**SUBDIVISION REVIEW SHEET (Variance Only)**

**CASE NO.:** C8-2013-0154

**SUBDIVISION NAME:** Park Place at Riverside

**DATE:** November 4<sup>th</sup>, 2013  
**TO:** Chair and Members of the Planning Commission  
**CC:** Don Perryman, Case Manager  
**FROM:** Caleb Gutshall, Transportation Review  
**SUBJECT:** Variance Request for Park Place at Riverside C8-2013-0154  
**RECOMMENDATION:** To approve the variance

OVERALL PRELIMINARY PLAN

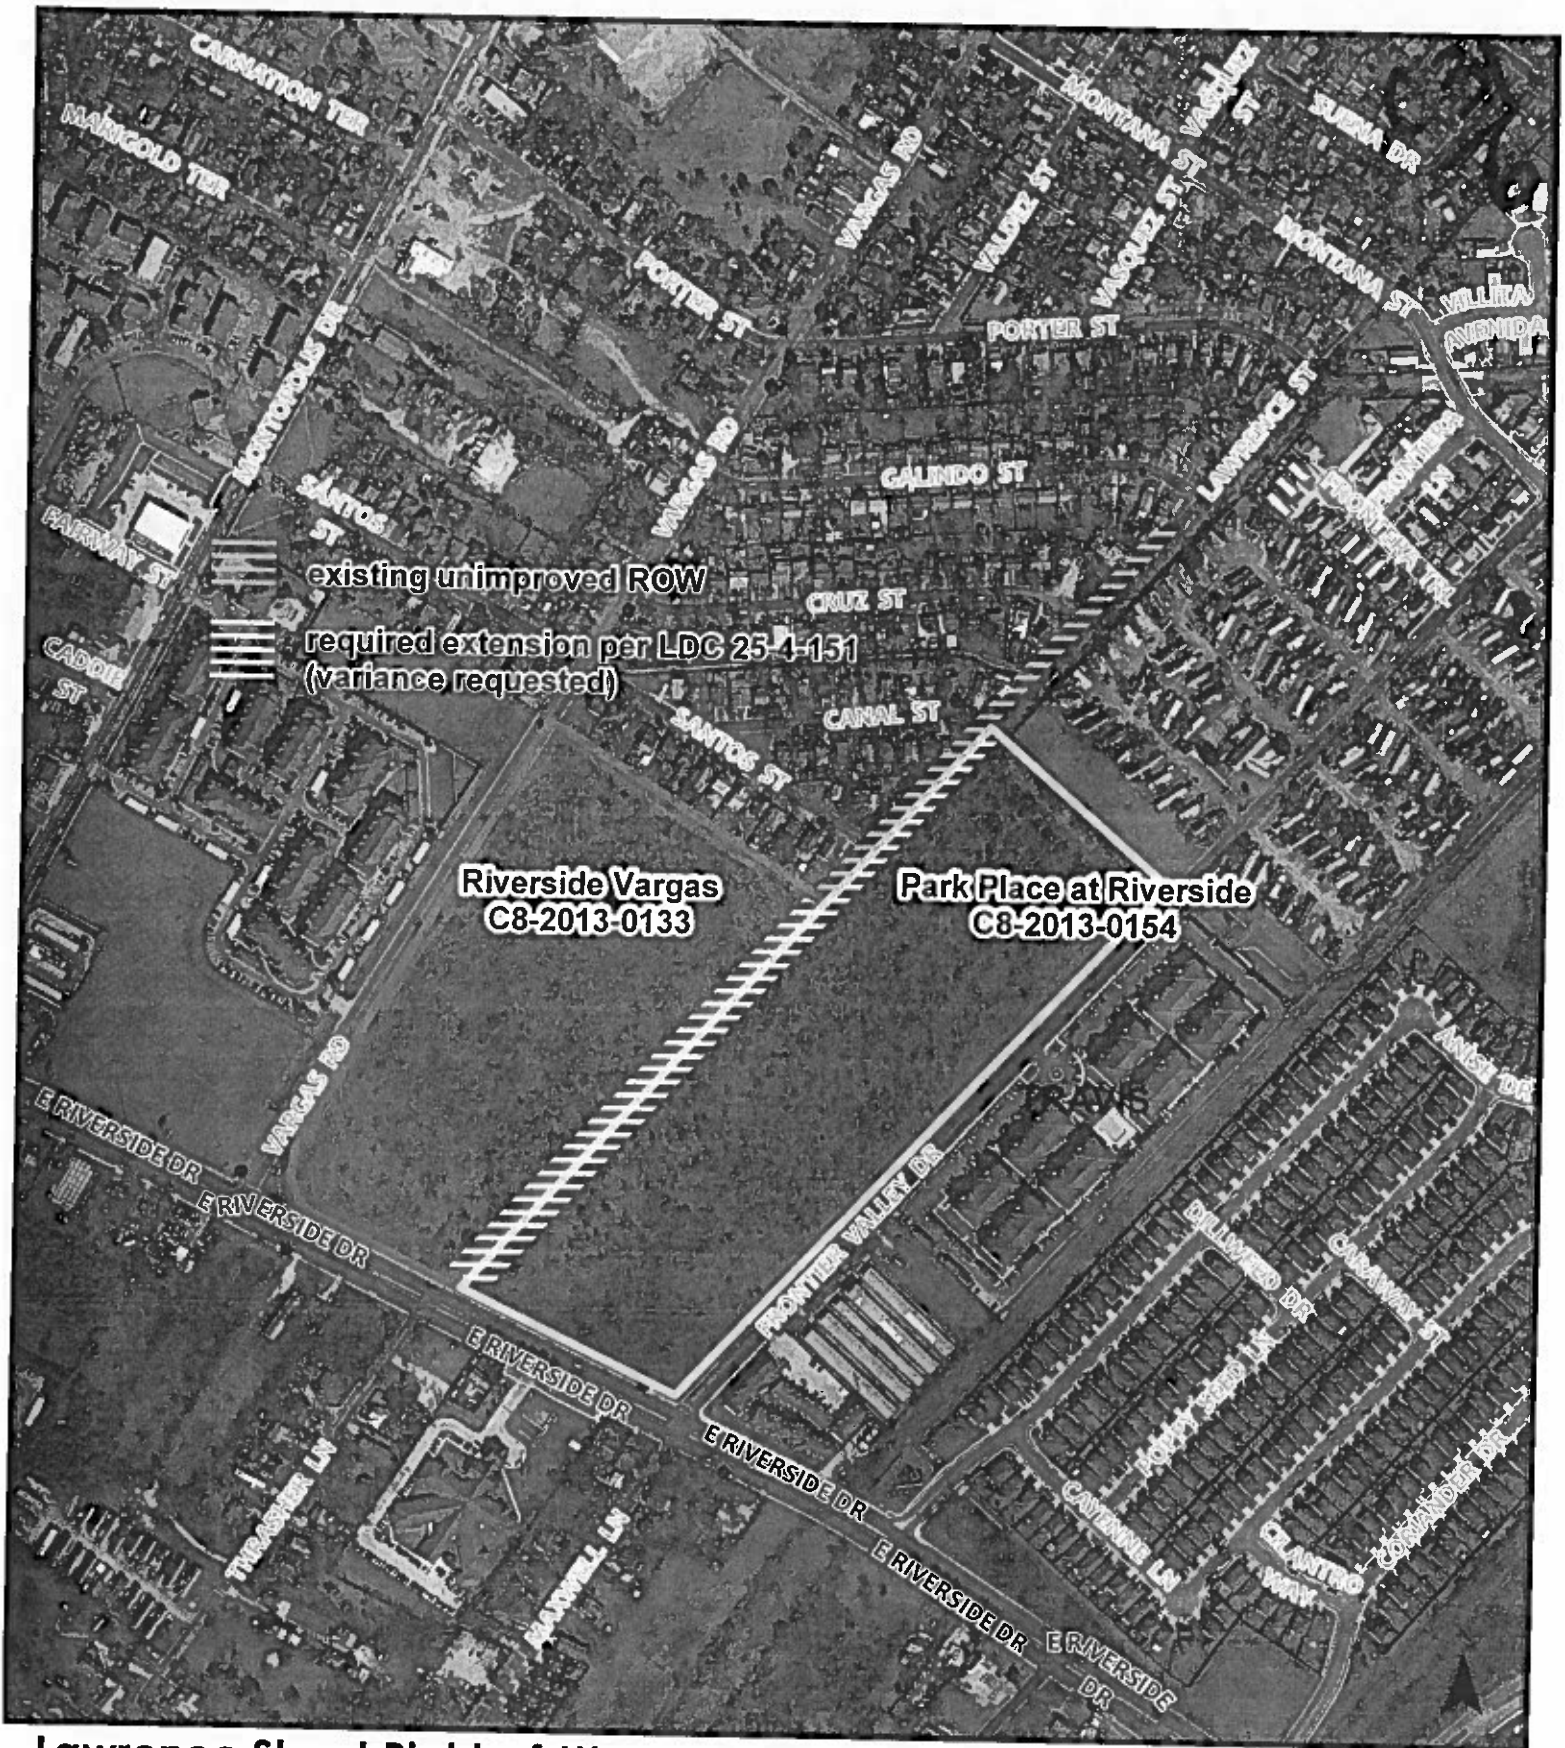
- The applicant is proposing to dedicate ROW for a roadway that runs north/south within the site and connects Riverside to Santos Street. The proposed roadway runs parallel to where Lawrence Street would be extended and provides additional connectivity and circulation to the neighborhood. Please see exhibit of the plan.

- The applicant is extending the existing Santos Street that runs east/west through the site and will connect to Frontier Valley. The Canal Street extension would run parallel to Santos Street. Canal Street is a local residential street 660' in length and terminates along the existing unimproved Lawrence Street ROW. The extension of Santos provides more intuitive connectivity than the extension of Canal Street.

- The applicant is providing additional grid-like roadways within the subdivision. The overall roadway network will enhance safety and traffic circulation, improves multi-modal connectivity, and adheres to the overall vision of the East Riverside Corridor Plan.
